MEMORANDUM

Name (if known): Walmart
Property Description: Lot 2 Green Mount
Site Address: 9305 Pocahontas Trail

(WAL-MART BULK STORAGE FACILITY # 6088, PAGE III)
BMP CODES # SC019, SC020, SC021, SC022, SC023, SC024

DRAINAGE AREA CALCULATIONS

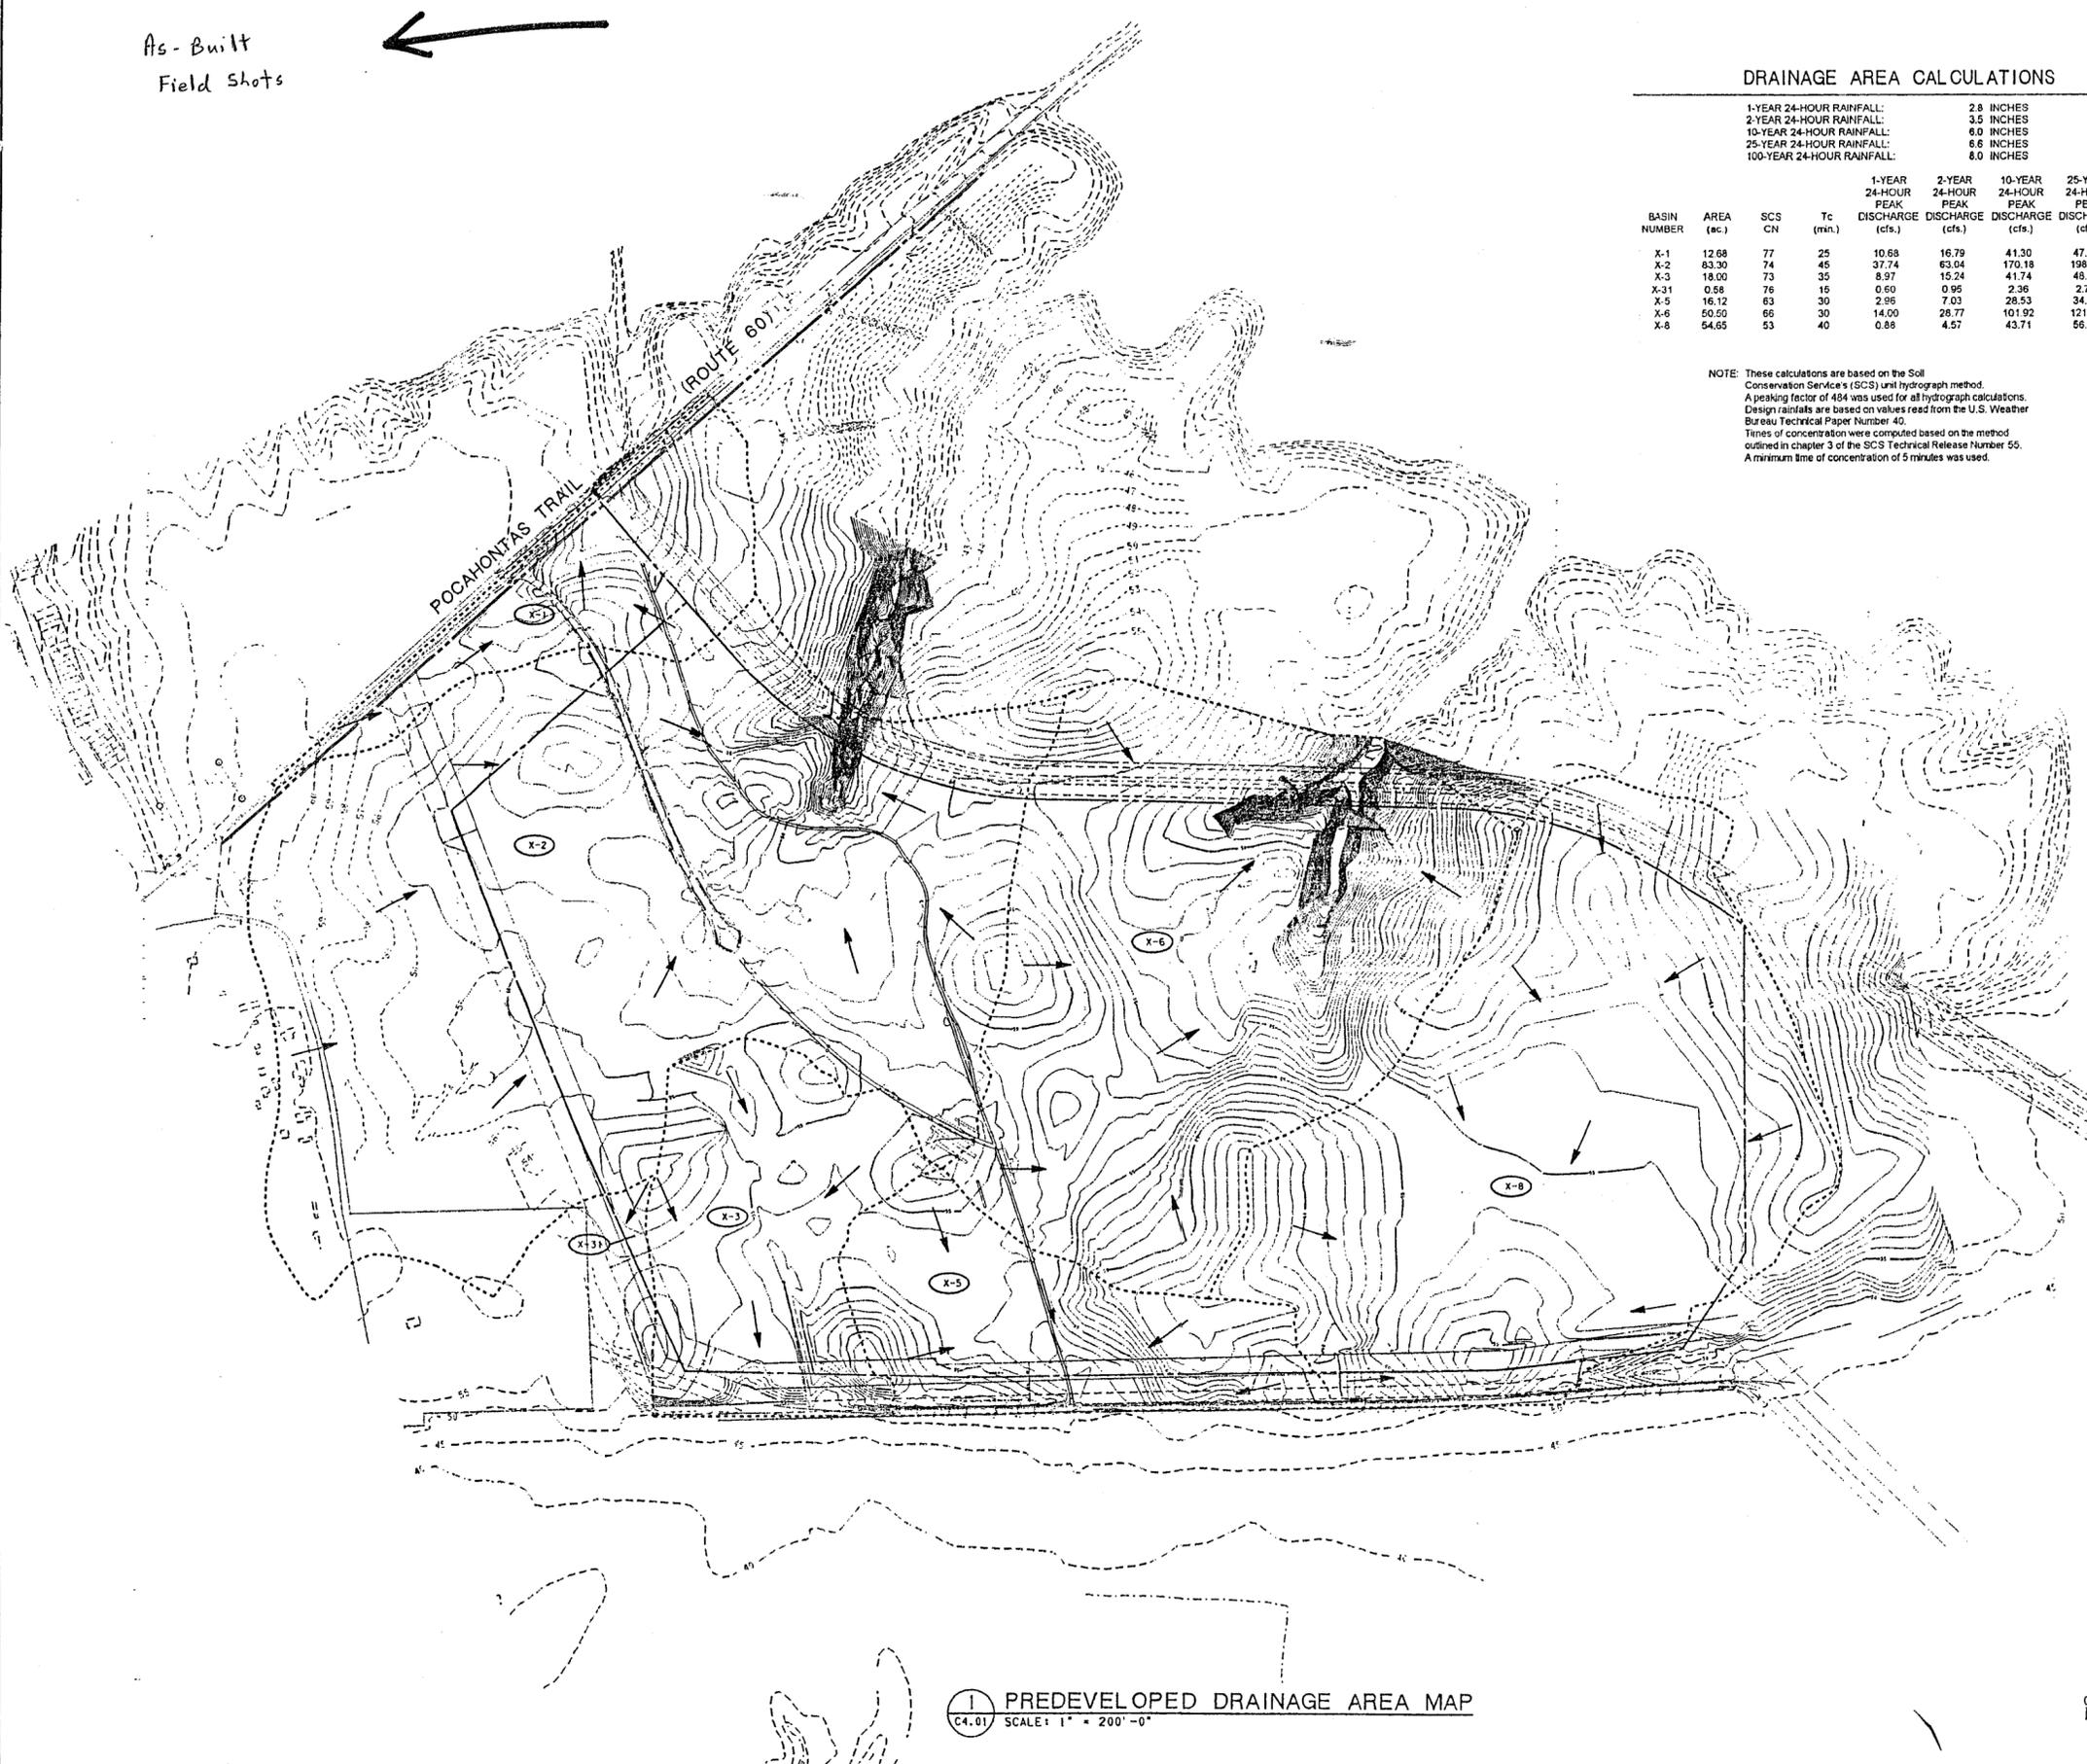
25. Predevelopment Hydrology. Please correct subarea X-1 predevelopment peak discharges on sheet C4.01 to reflect values as determined in the drainage report.

HYDRAULIC CALCULATIONS

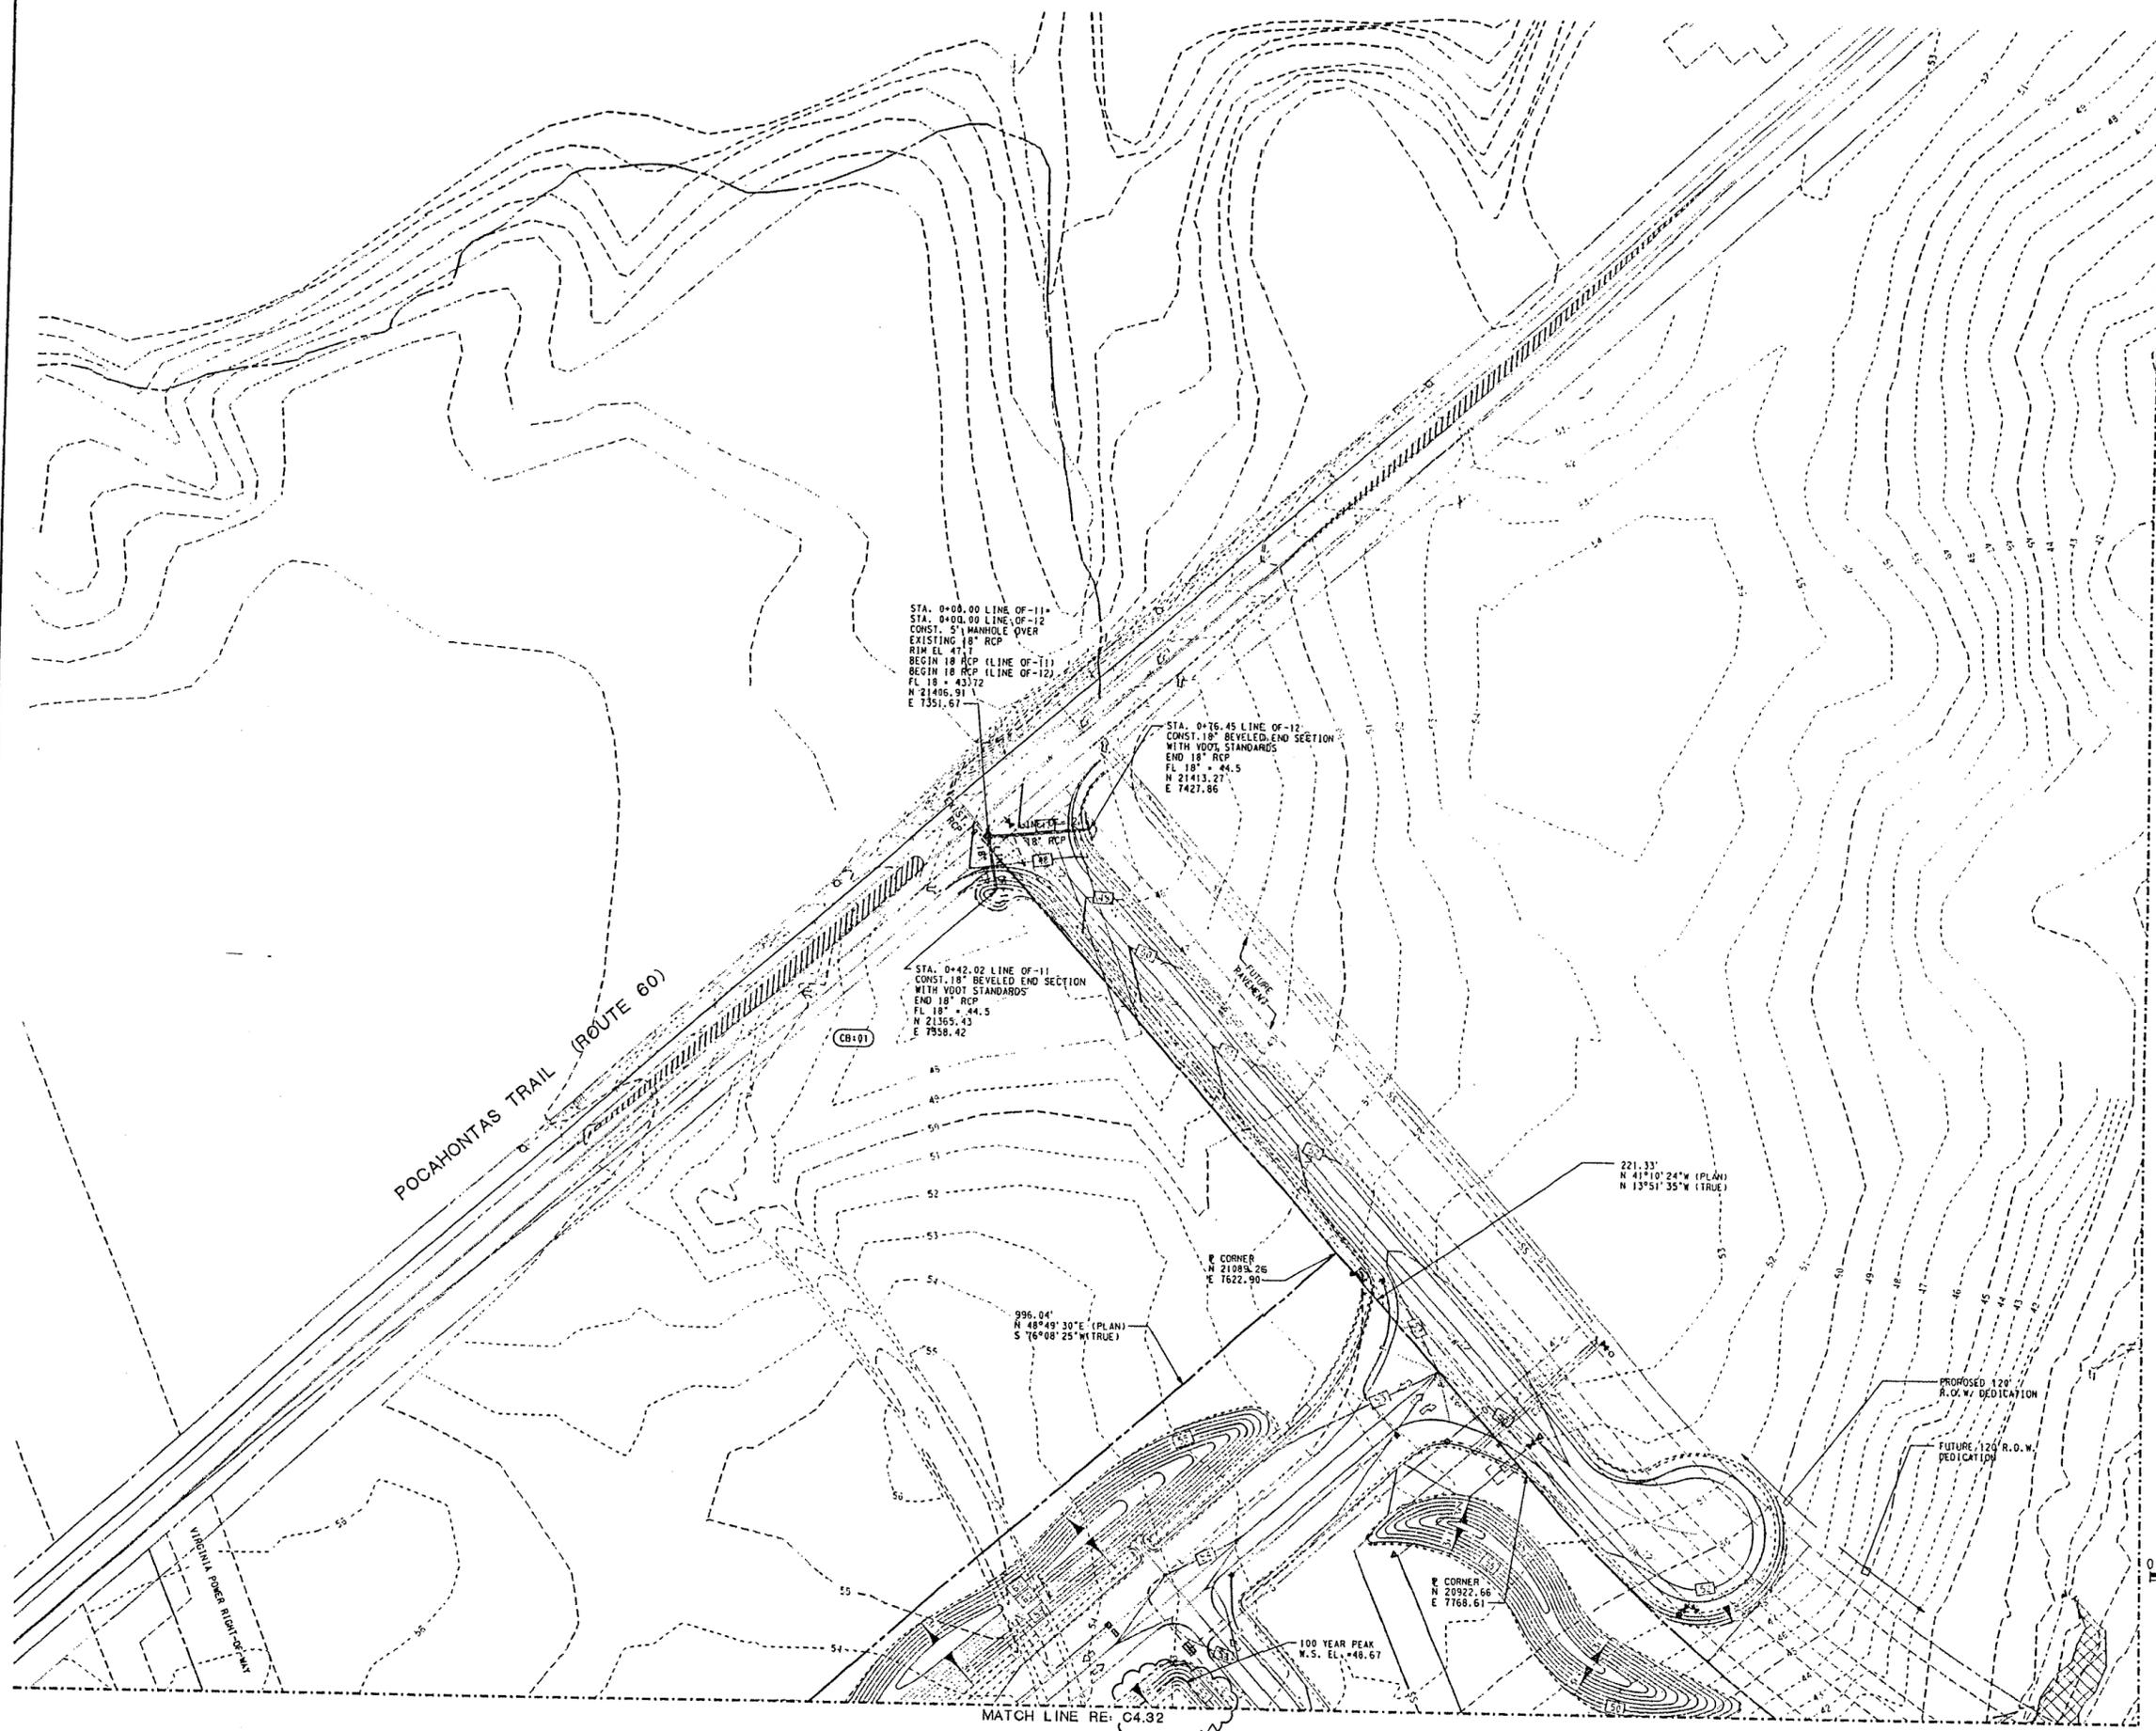
12. Stormwater Conveyance Channels. On sheet C4.11 add lining required (ie. grassed, EC-2, EC-3, etc.) to the open channel hydraulic table. Channel segments CH-C80 and CH-D70 will require a soil stabilization blanket for erosion control due to design velocities greater than 4 feet per second. Refer to the VESCH, Minimum Standard 3.36 for Treatment-2 (EC-3 Type A) for design velocities ranging from 4 to 10 feet per second. Based on our local experience, EC-3 lining is preferred over EC-2 (jute type) for erosion control and vegetation establishment.

39. Storm Culverts. Based on hydraulic computations shown on the table on sheet C4.11, road culvert headwater elevations for B-1, B-2 and B-3 exceed the given design centerline roadway or top of berm elevations. On sheet C4.41, show the 10-year WSEL for Line B-3.

SHEET
C4.53

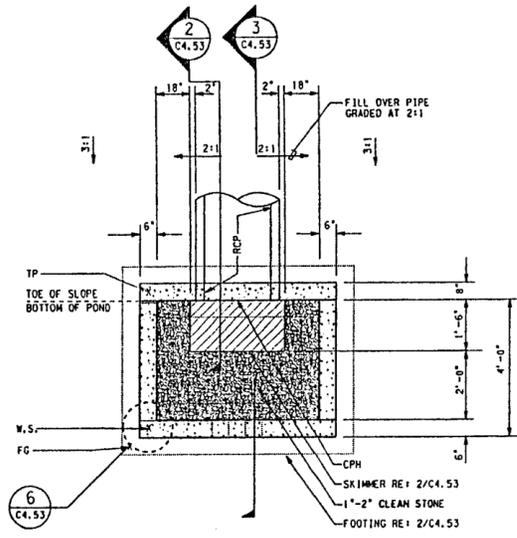
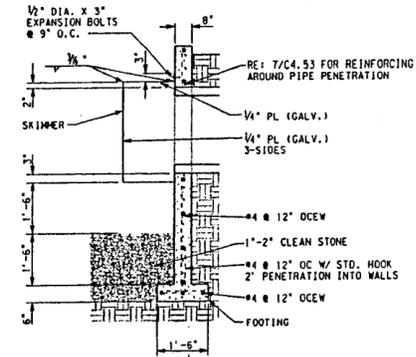
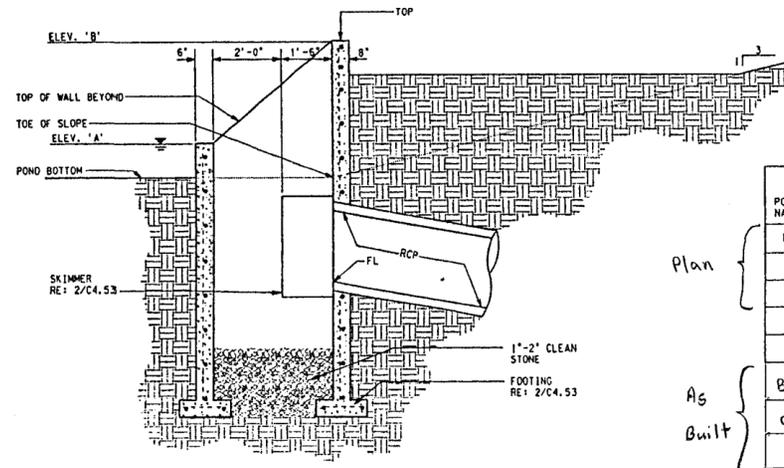
- * 33. Outfall Structure Details. No design data was shown in the outfall control structure schedule (table) on sheet C4.53. No dimension was shown on detail 3 between the pond bottom and top of concrete on the inside face of the structure. Final elevations or dimensions are required for construction purposes for all structural aspects associated with the outfall control structures .

- * 34. Outfall Structure. The erosion and sediment control narrative mentions that the outfall control structures will prevent the bottom six inches of volume in the ponds from discharging; however, detail 1 and 3 on sheet C4.53 shows dual 6" x 6" bleeder orifices at the bottom of pond elevation. Please explain.
